Arrawarra Flood Assessment Independent Review

Woolgoolga to Ballina Pacific Highway Upgrade

Draft Report

INDEPENDENT REVIEW OF ARRAWARRA FLOOD MODELLING WOOLGOOLGA TO BALLINA PACIFIC HIGHWAY UPGRADE

Diagram 1: Woolgoolga Rainfall Gauge - Events Exceeding 290 mm over two days.

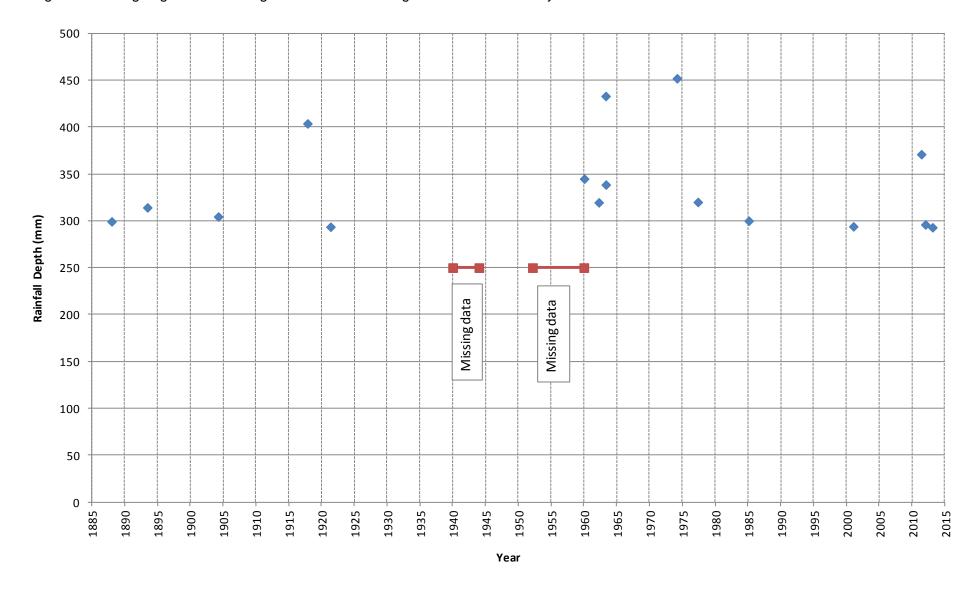
Diagram 1 (following page) displays major rainfall events from the long-term daily rainfall records at Woolgoolga. The chart displays occasions when more than 290 mm of rain was recorded over a two-day period. The two-day period was selected because major events will often straddle the time when the gauge is read (usually 9am), such as occurred in January 2012.

The historical investigation indicates that January 2012 event was probably among the largest in recent decades, but is not unprecedented in terms of the total depth of rainfall or the height of floodwaters that may have occurred since the 1880s.

2 year ARI to 5 year ARI (or 50% AEP to 20% AEP) estimate provided by the APBJV. The review of historical information in Section 1.3 indicates that the 48-hour rainfall, which is assessed as the critical duration for major sub-catchments of Arrawarra creek, was among the heaviest on record for nearby long term gauges. There is potential for significant localised variation in rainfall measurements, however it must also be considered that the relatively conservative tailwater estimates of the APBJV modelling (Section 2.4.2) skew the assessment of more frequent events. For example, the levels quoted in Table 4-8 of Reference 1 are in the range of 2.0 mAHD to 2.75 mAHD, with a ground level of 1.85 mAHD. These levels are quite close to the ocean tailwater level of 2.1 mAHD adopted for the modelling (the ground level is below – but obviously is not frequently inundated by tides). It is therefore considered likely that this tailwater assumption has an influence on this assessment of the rarity of historical floods (although it is not a significant issue for the assessment of the Pacific Highway works).

- Strong evidence that in the Corindi River, the January 2012 event was in the order of a 100 year ARI event (Reference 10); and
- The prominence of these events in long term rainfall records at Woolgoolga (see Diagram 1).
